Urgent Field Safety Notice

Applicable to REPLY, ESPRIT, KORA and FACIL¹ pacemakers
manufactured by Sorin Group Italia S.r.l.

Improved residual longevity displayed by the programmer

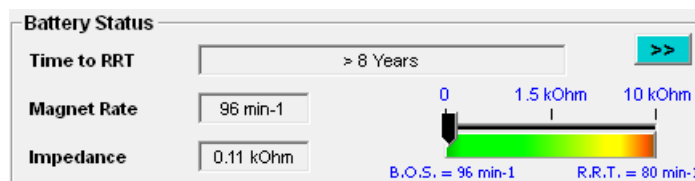
- If the **typical estimated time to RRT** is **>3 years**, the “*typical time to RRT*” is displayed and the corresponding text field background is grey.

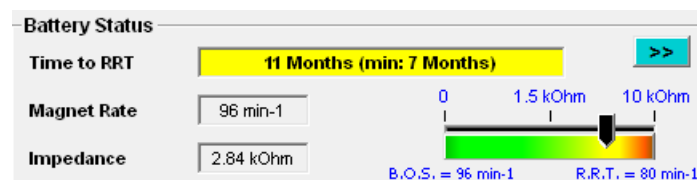
- If the **typical and minimal estimated time to RRT** are **between 3 months and 3 years**, the “*typical time to RRT in years and months (Minimal time to RRT)*” are displayed and:
 - the corresponding text field background is grey, if the **minimal estimated time to RRT** is **>12 months**;

- The corresponding text field background is yellow, if the **minimal estimated time to RRT** is **≤12 months**. A Warning will be displayed “*In the current conditions of use, the minimum residual longevity ≤ 12 months.*”

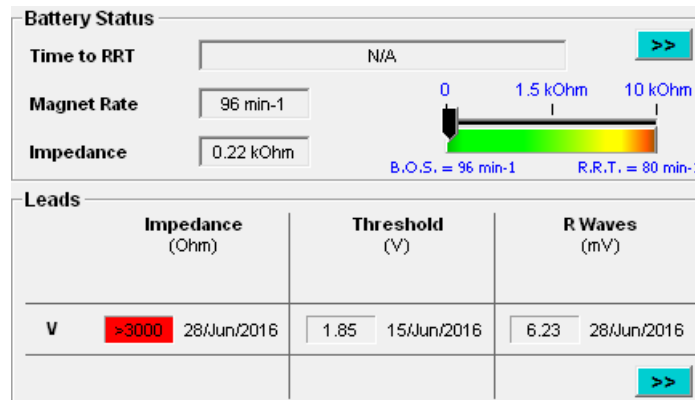
- If the **minimal estimated time to RRT** is **<3 months**, “< 3 months” is displayed and the corresponding text field background is orange. A Warning will be displayed: “*In the current conditions of use, the minimum residual longevity ≤ 3 months.*”

- If the **RRT has been reached**, “RRT has been reached” is displayed and the corresponding text field background is red.

- “NA” is displayed in the text field, and the corresponding text field background is grey:
 - If less than 5 minutes statistics are available (i.e. first interrogation at implant, device reset),
 - If lead impedance is abnormal (< 200 and ≥ 3000 Ω) in any of the programmed cavity.
